CORRECTIONS AND MODIFICATIONS TO ELECTRIC VERSION OF CLOUD WALKER

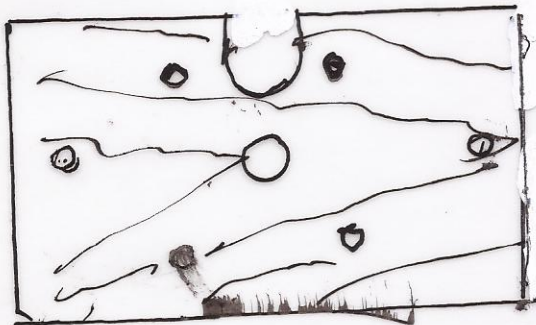
Correct shape for A3 battery hatch base

Correct shape for front former of battery hatch.

1/8" ply motor mount for modified mount.

NOTE there is plenty of spare ply on the laser cut sheets to cut these parts out.
